DOCUMENT CHANGE NOTICE (DCN)

DOCUMENT No. (DOC-REV-GP. ID)	TITLE	NEW REV.
D990513-00	ETM Alignment Bracket - Slotted	A
D990521-00	ETM Alignment X-Beam	A
D990522-00	ETM Alignment Vertical Support	A
D990523-00	ETM Alignment Bracket	A
D990526-00	ETM Alignment Tooling Installation	A
D990534-00	ETM Alignment Backplate	A

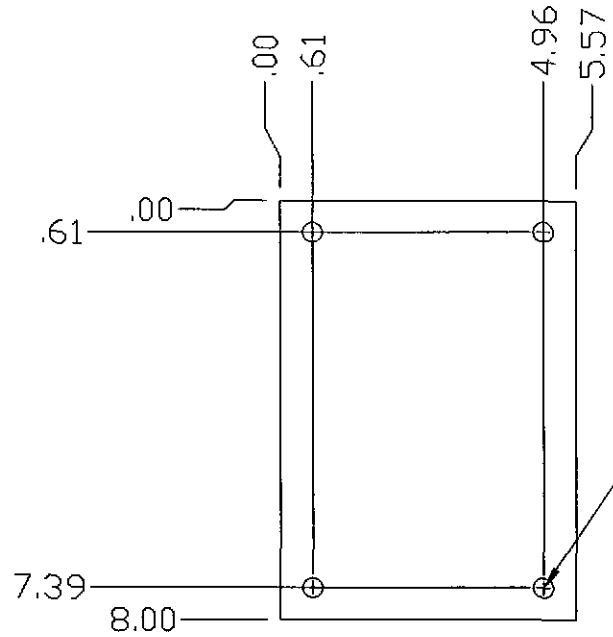
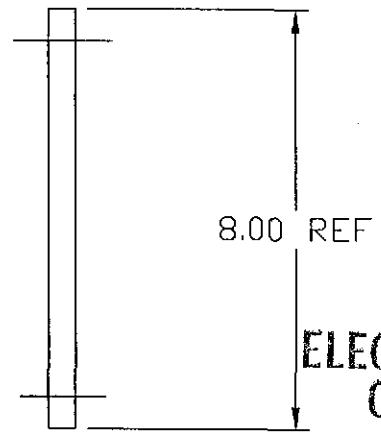
D990534: Changed overall length from 7.61 to 8.00. Changed verticle hole dimension from 7.00 to 7.39.
